## ANN ARBOR HISTORIC DISTRICT COMMISSION

### Staff Report

**ADDRESS:** 217 Third Street, Application Number HDC16-282

**REPORT DATE:** December 8, 2016

PROPOSED 2ND FLOOR PLAN

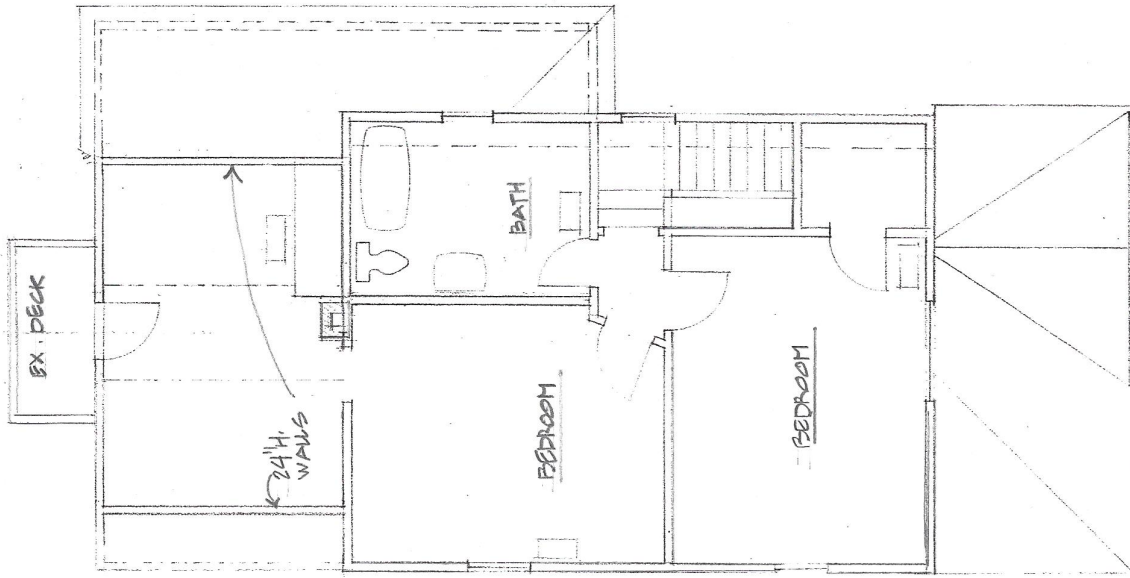
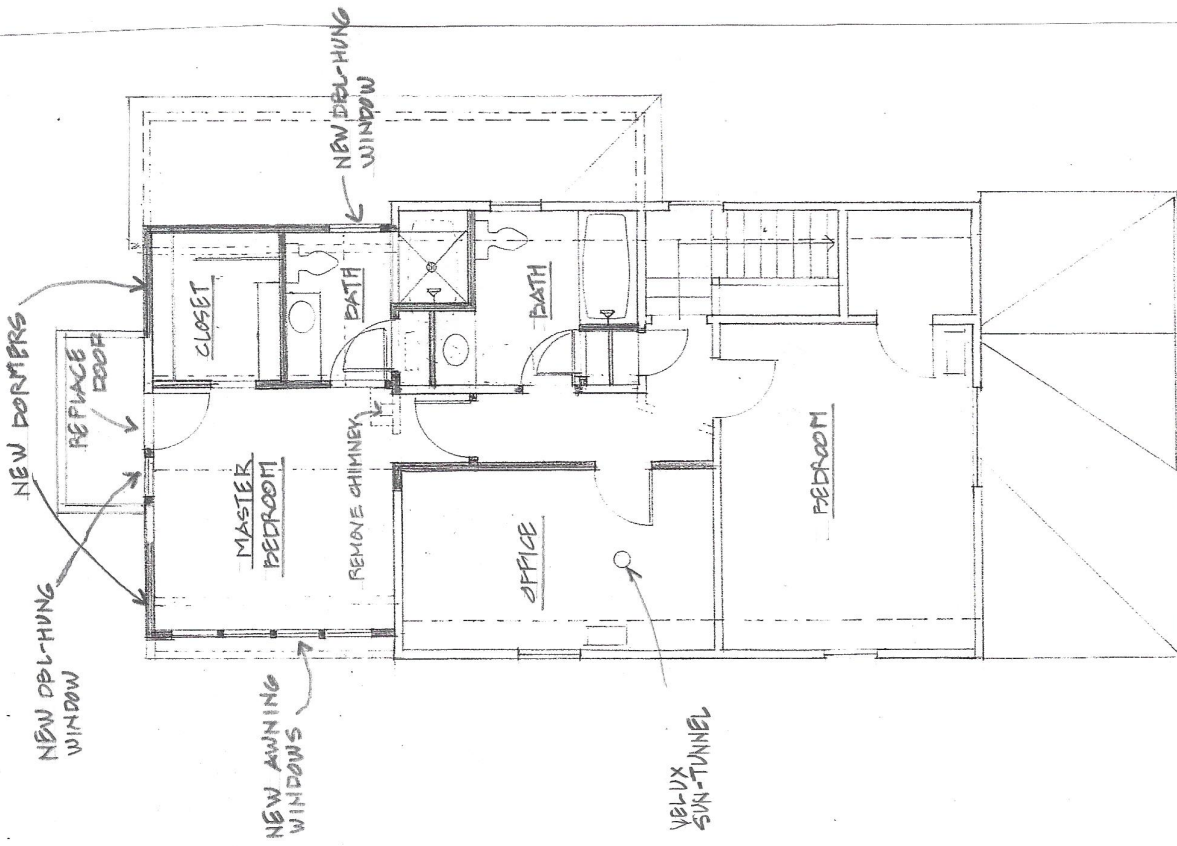
2. On the rear wing, staff believes the design of the shed dormers is inconspicuous and appropriate. On both sides they are stepped in from the rear corners of the house, and the original trim in both rear-facing gables is maintained. The chimney on the back of the house is red brick and has no distinctive character or architectural features. Its removal would allow the recapture of significant interior space on both floors. All windows on the dormers and a new window next to the rear balcony door are Andersen aluminum clad wood. Replacing the balcony door on the rear wing with a full-lite fiberglass door that fits the current opening is appropriate.

PROPOSED SOUTH ELEVATION

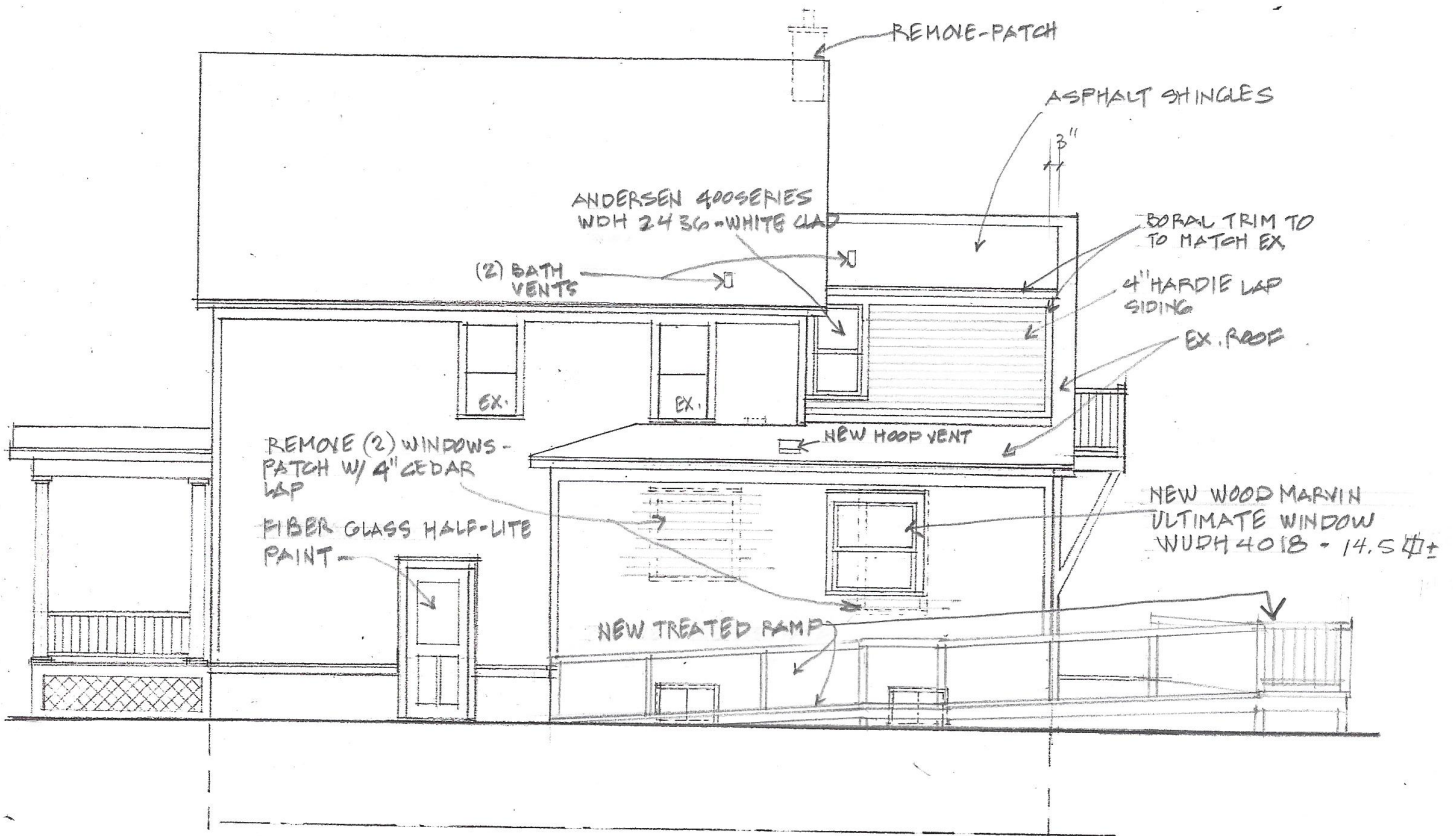
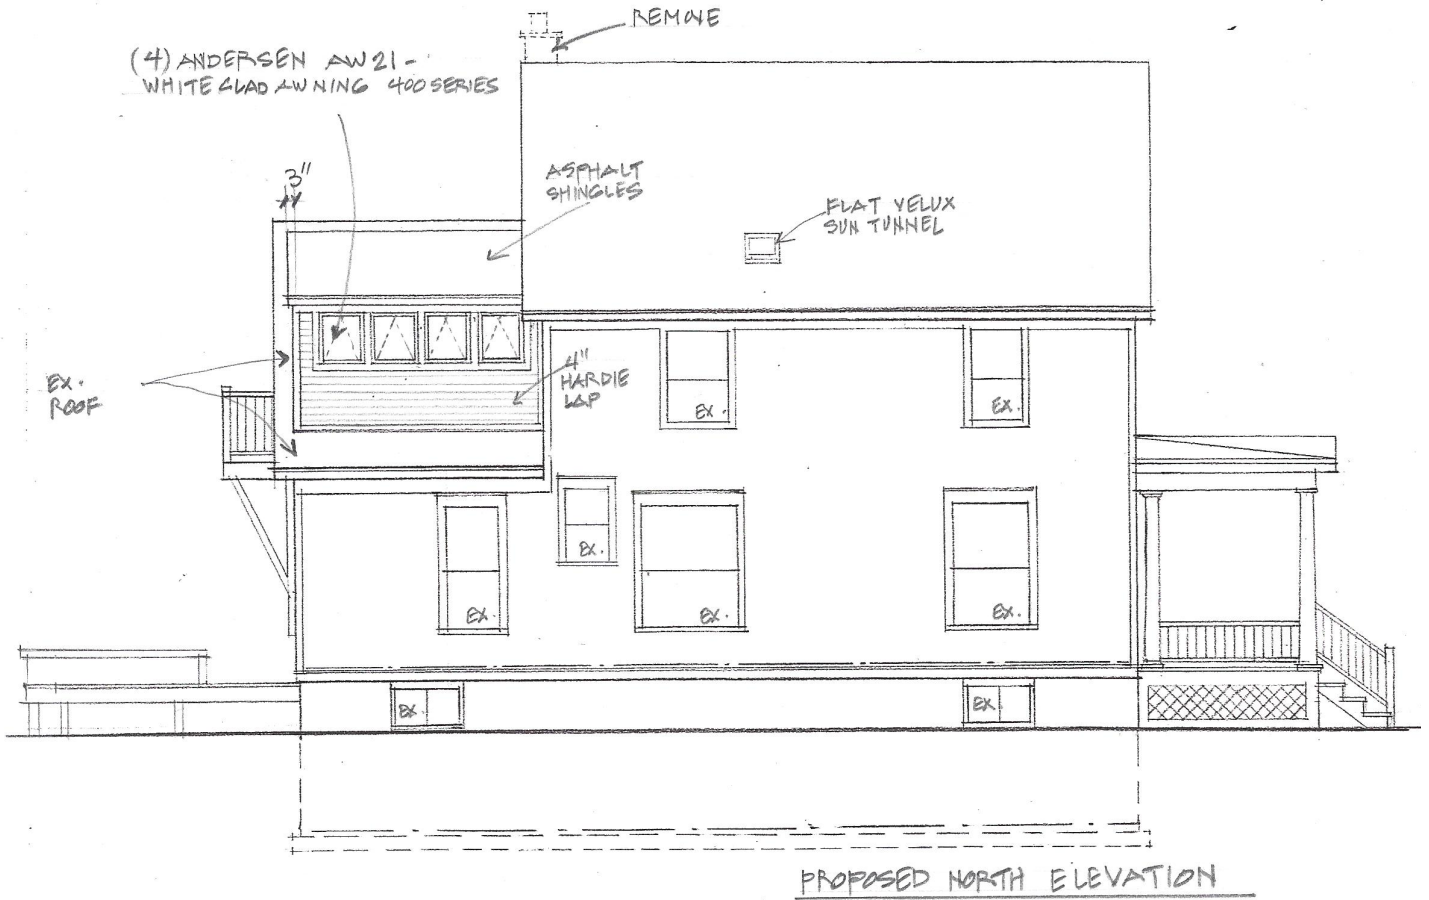
3. The windows facing south on the first-floor bumpout are not original. The one on the left in the application photograph has different proportions than those on the rest of the house. It is unclear whether the bumpout was previously a porch that was enclosed, or if it was always finished space. On the left-hand window, since neither the window nor the opening are original, and there is no evidence that a different-sized window used to be there, staff believes this window's removal is appropriate and doesn't affect the architectural integrity of the house. The right-hand window is more likely to be an original opening size. The proposed replacement is approximately the same width as the left-hand window (3'6") but is taller (approx. 4'1"). If the commission believes replacing this window with a larger one meets the standards and guidelines, then staff feels that the size of the replacement window is acceptable since it is taller than it is wide and will be the only window on that face of the bump out. The proposed replacement window is all wood.
